**Warehouse Development at  
College Lane, Greenogue,  
Rathcoole**

**Flood Risk Assessment**

**Final Report**

This letter addresses the request for the clarification of additional information in relation to planning application SD18A/0265 for a site in Rathcoole Co Dublin. The proposed development is for two industrial warehouses and associated parking facilities. Please find included below a response to Items 1 through to 4 of the South Dublin County Council Request for Clarification of Further Information.

Figure 1: Revised Flood Mitigation Design Schematisation

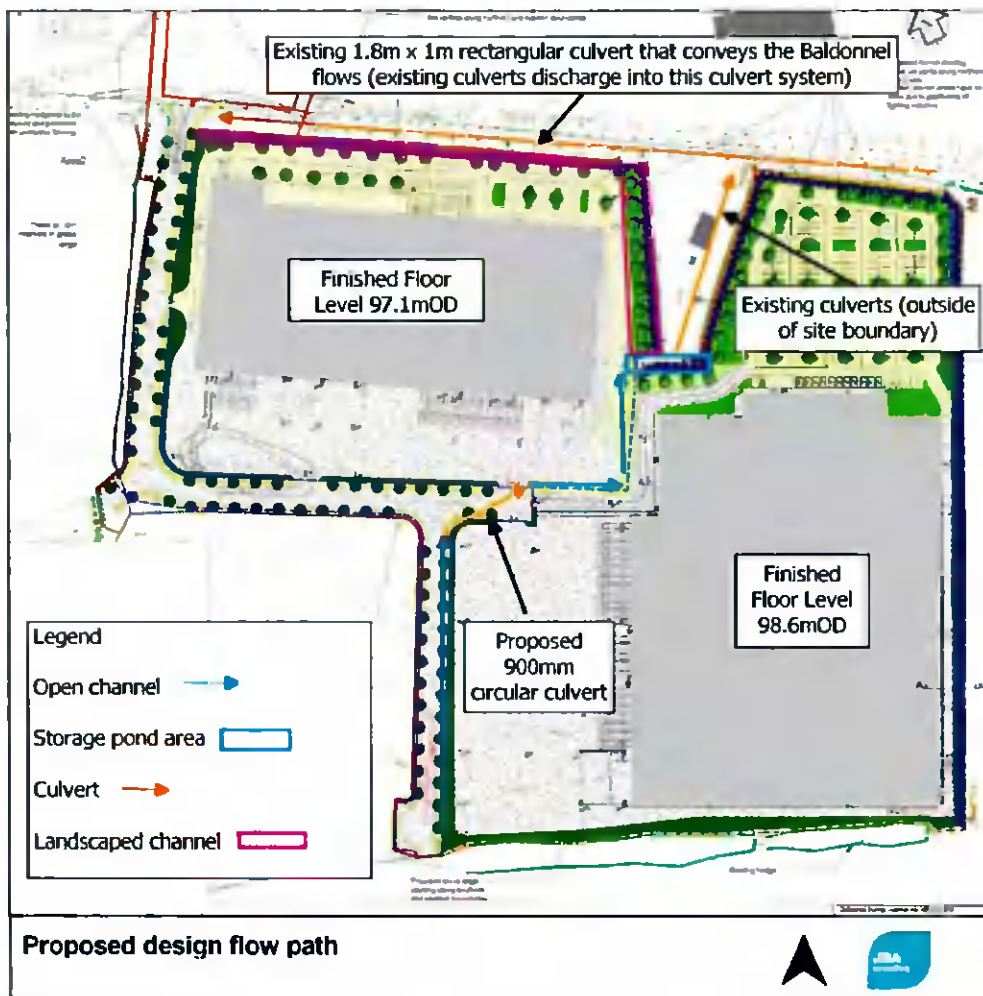
3	<p>The Planning Authority has concern that the proposed culverting of the stream that runs through the centre of the site would have significant effects resulting from the rapid transport of flood waters downstream.</p> <p>Furthermore, the proposed culvert is contrary to Development Plan policy on green infrastructure and retention of landscape features. The applicant is requested to address this issue.</p>	<p>This comment has been noted and taken in to consideration within the revised flood mitigation design. In the revised design the watercourse remains as open channel across the site. A proposed re-alignment of the channel increases it's overall length by c. 30m, increasing travel time and attenuation within the watercourse, thereby reducing potential for negative impacts of flood waters downstream.</p> <p>A culvert 900mm in diameter and c. 25m in length however is still included within the centre of the site as a requirement for internal road access. This culvert has been robustly tested within the hydraulic model which confirms no increase to flood risk.</p>

As depicted in Figure 1, the watercourse is proposed to be realigned through the site. The watercourse will predominantly remain as an open stream as per the requirements of SDCC. It is proposed that a single 900mm culvert c. 25m in length will be included to allow internal traffic flow over the watercourse. The total channel length is increased by 30m compared to the existing channel on site.

During extreme flood events such as the 1% AEP flood event and when the capacity of the existing culverts downstream of the site are exceeded, the excess flow will be directed into a shallow open diversion surface flow channel that runs around the northern boundary of the site. The diversion channel has been designed to replicate the existing greenfield flood behaviour onsite. The diversion flow channel is activated only during high flow events and is controlled by a set spill height of 96.50mOD. The diversion flow channel is contained by a boundary wall and a raised kerb on the left bank and the site boundary wall on the right bank. All are constructed of reinforced concrete.
